Fearna Pumped Storage Hydro Scheme - EIA Report

Additional Information Report

December 2025

Plate 3 – Upper Control Works – Plan on Revised Design

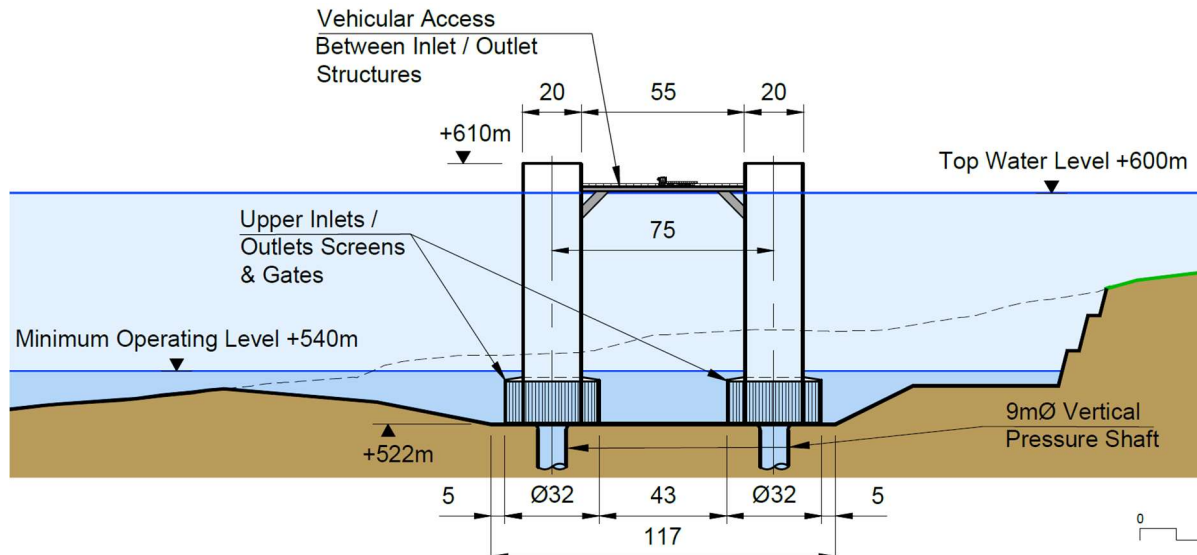
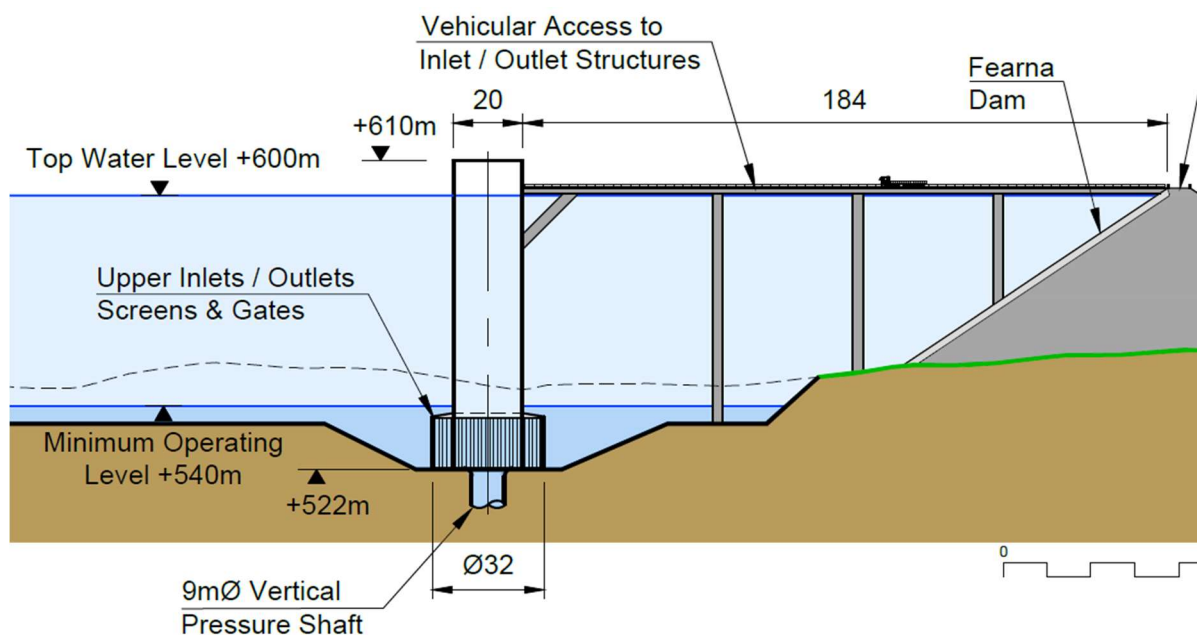
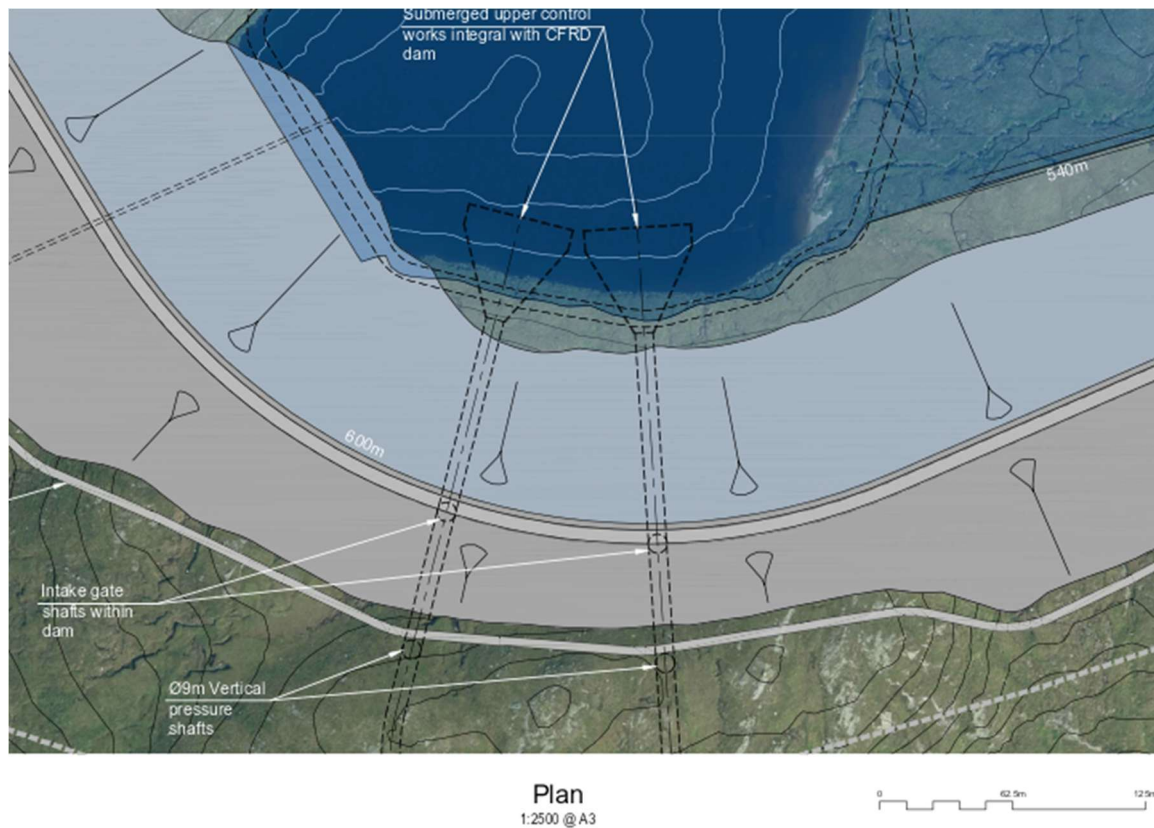
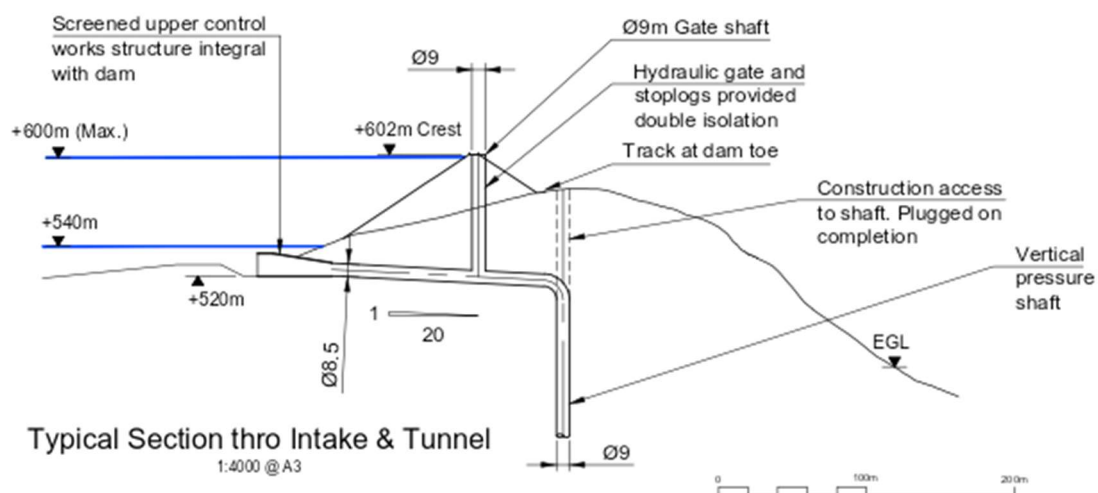
1.2.6 In order to reduce the landscape and visual impact of the Fearna Reservoir upper control works, the two circular reinforced concrete intake towers linked to the Fearna dam and to each other by steel gantries have been removed and replaced with structures that are within the body of the Fearna Dam and permanently submerged within the reservoir below its lowest operating water level.

1.2.7 The preliminary hydraulic design which was conducted pre-planning required that vertical pressure shafts were required to drop directly from the upper reservoir, to avoid vacuum occurring in the underground waterway system. This scenario must be avoided in the operation of pumped storage hydro plants.

1.2.8 Vertical upper control works structures were required accordingly, located directly above the pressure shafts. These structures would provide the following functions:

1.2.9 The upper control works structures would have been approximately 80m high, 20m in diameter and constructed from reinforced concrete. The screen structures at the base would be 32m in diameter to create the required screen area, however this wider base section would have been permanently submerged within the upper reservoir. When the reservoir was full, approximately 10m of the silos would have been exposed above the water. This would increase to 70m when the reservoir was empty.

1.2.10 The location of the pressure shafts and thus the upper control works was originally required to be separate from the dam structures. Gantry structures with supporting piers would therefore have been required to access them, which would have been designed to take HGV loads. The gantries would have been located above maximum water level and therefore always been visible. **Plate 1** and **Plate 2** below describe the details of the originally submitted S36 design:

- 1.2.11 The development and refinement of the design have identified alternative feasible options which do not require separate upper control works structures. Instead, the screen and isolation gate requirements can be accommodated within the Fearna dam structure. The screens would be permanently submerged at or near the base of the dam and the gate shaft would be constructed within the rockfill dam section. As a result, none of this infrastructure would be visible. This would remove these significant structures and associated vehicle access gantries from the upper reservoir and from within WLA 18.
- 1.2.12 The revised arrangement is shown in **Plate 3** and **Plate 4** below, and in the updated **Figure 2.7 E2**.

Plate 6 – Allt a' Mheil track viewed from Gairich summit

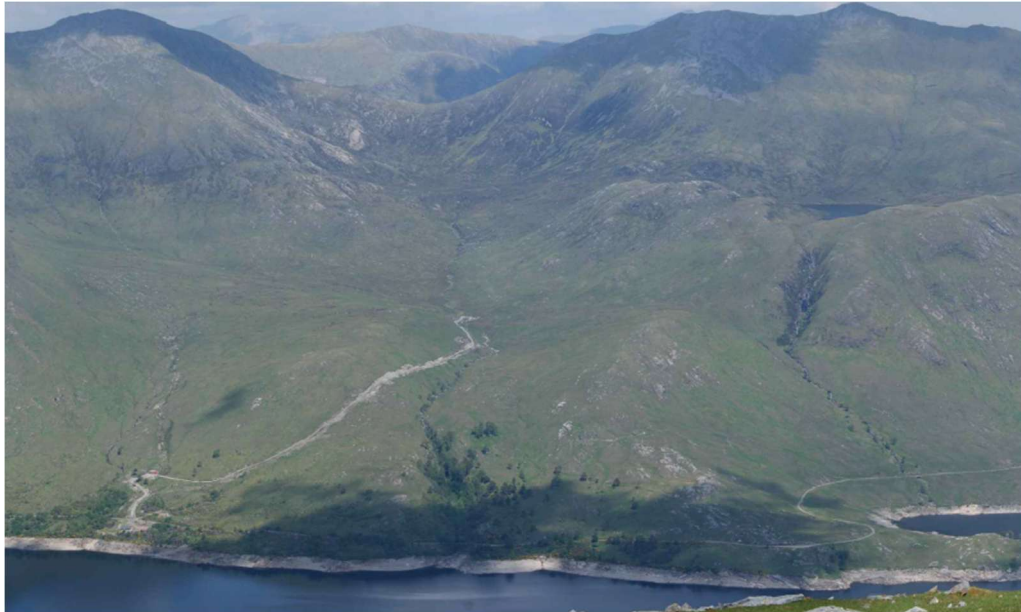
- 1.2.23 The existing 500kW Allt a' Mheil hydropower scheme is located downstream of the proposed Coire Dubh dam. The intake structure on the Allt a' Mheil burn is accessed via an access track of the C1144 public road. This track is a poor example of an upland access track due to the following:

- Very steep gradient of up to 1:5 in places, which creates unsafe conditions both when ascending and descending, especially in poor weather;
 - Poor alignment – the track generally runs straight up the steep hillside, rather than using the natural contours;

- Poor reinstatement – very thin soils were placed on the verges and the underlying granular material shows through. Revegetation has therefore been substandard;

- Poor drainage – runoff flows down the track on the steep sections, causing washout of the material. On shallower sections, ponding occurs due to lack of crossfall and poor roadside ditches;

- Surface – loose gravel material has been used, which dislodges due to runoff and wheelspin on the steep sections;
 - Poorly reinstated borrow pit; and

- 1.2.24 The issues identified above create greater visual impact than a properly designed and well reinstated upland access track.
- 1.2.25 The pressure pipeline is buried within the verge of the access track, including several air valves, which require to be accessed for periodic maintenance. It is therefore proposed to reinstate the access track to remove it as a visible feature within the landscape. During future maintenance, the air valves and pipeline can be accessed by Argo or small excavator without the requirement for a track.
- 1.2.26 The proposed Fearna access track would pass very close to the Allt a'Mheil intake and therefore the Allt a'Mheil operator would use the Fearna track for routine maintenance.

This would also provide a significantly safer option than the current track and the landowner agreements have included this provision.

- 1.2.27 This measure would both provide on-site improvement of the cumulative visual impact of access tracks within the WLA designation and improve biodiversity.

Plate 8 – Section through SAR Screening Bund at Loch an Staic

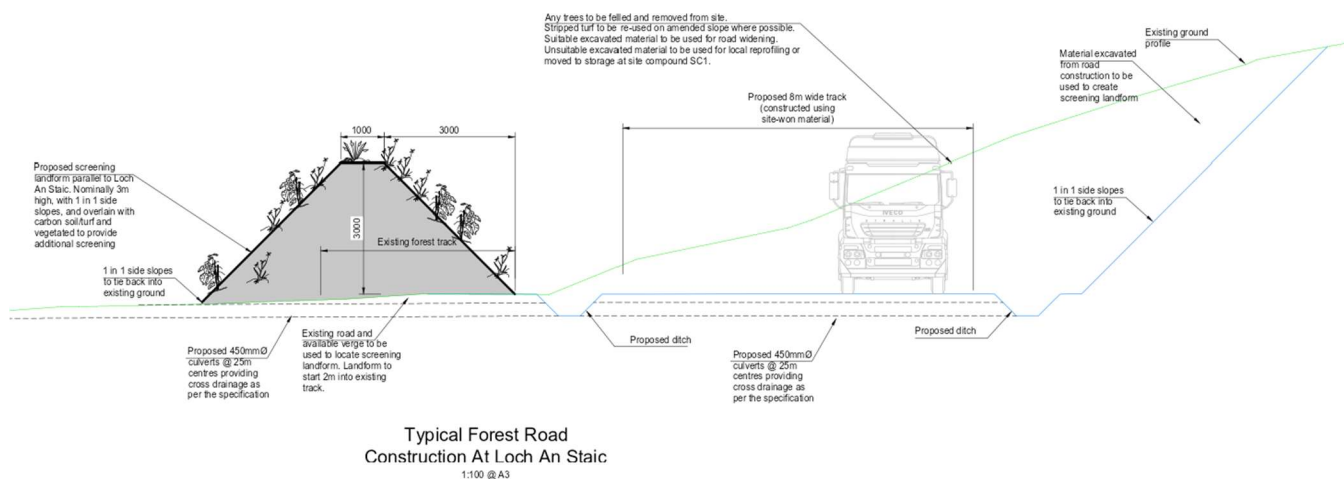
- 1.2.32 To reduce potential disturbance of sensitive avian receptors on and around Loch an Staic by construction traffic using the SAR, a landform screening bund is proposed over a length of approximately 770m. Details are given **Plate 8** below and in **Figures 2.14 E2 (Sheet 11) and 2.43 E2**.
- 1.2.33 The construction of the bund would comprise the excavation of granular material immediately adjacent to the existing forest road, on the northern side. This material

would be deposited on the existing roadway to create the bund, with the new section of forest road running through the excavated area, screened from Loch an Staic. Peat, turf and topsoil would from the excavation would be used to reinstate and vegetate the screening bund.

Plate 9 – Additional native woodland areas within site boundary

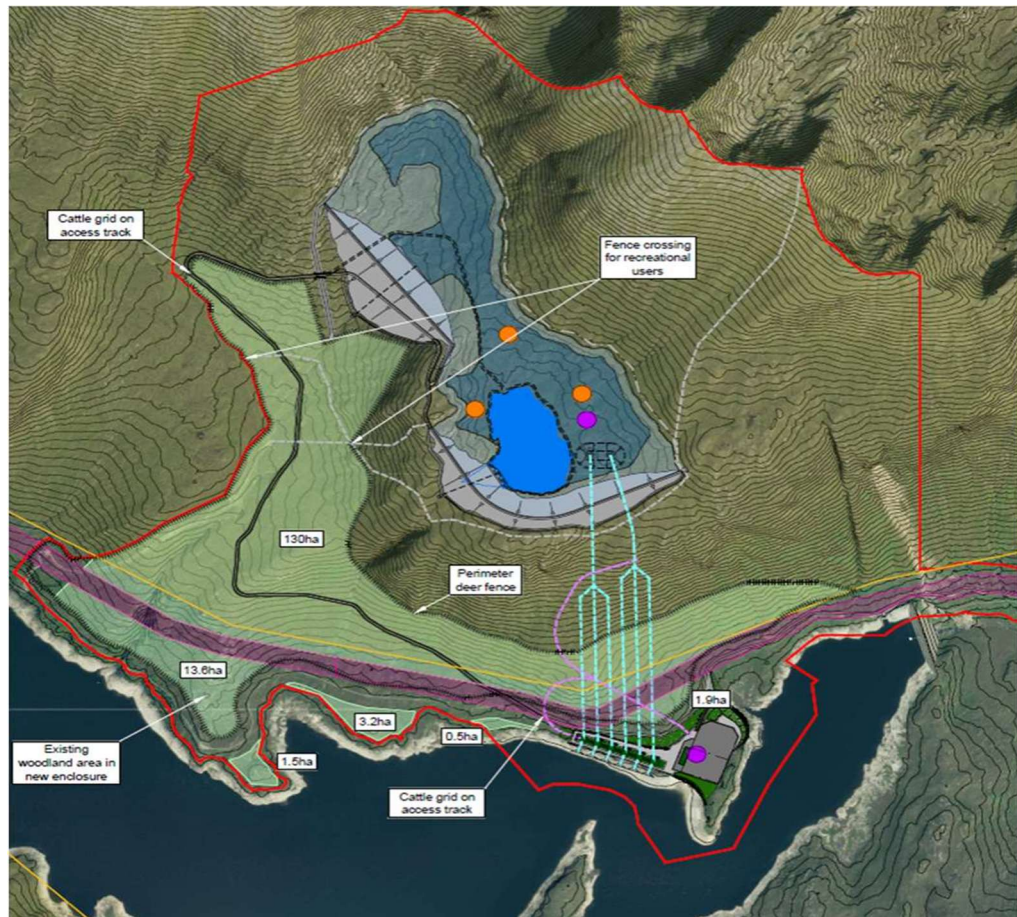
- 1.2.35 Further opportunities to create areas of on-site native woodland have been identified, which would improve the landscape and visual impact of both the Fearn PS and the Skye 132kV transmission infrastructure. Additionally, this would provide significant biodiversity improvements on the main PS site.

- 1.2.36 A gross area of 130 hectares has been identified within the site boundary. In addition, this area would combine with the area of existing Caledonian pine and proposed Rhododendron eradication and native woodland regeneration, which has now been extended to the west since the original S36 application. This area now comprises 204 hectares, 115 hectares of which would lie within the boundary of WLA 18. This is shown in **Plate 9** and further detailed in **Section 1.3** below.

- 1.2.37 Further details will be developed, however at this stage a species mix reflective of existing Caledonian forest including Scots pine, rowan, birch aspen and alder is proposed on the lower slopes. Montane scrub including species such as willow, juniper, birch and rowan is proposed for areas within the upper corrie to promote biodiversity and would be appropriate to the WLA landscape character.

- 1.2.38 Planting would be considered sensitively to avoid increasing the appearance of a heavily managed landscape. Any mechanical works would be kept to a minimum and planting carried out by hand where possible. The design of planting areas would be considered sensitively, particularly the scrub, with denser and irregular clumps of planting interspersed with open areas intended to reflect natural growth patterns. The exclusion of deer from these areas by fencing would also encourage further regeneration of native scrub.
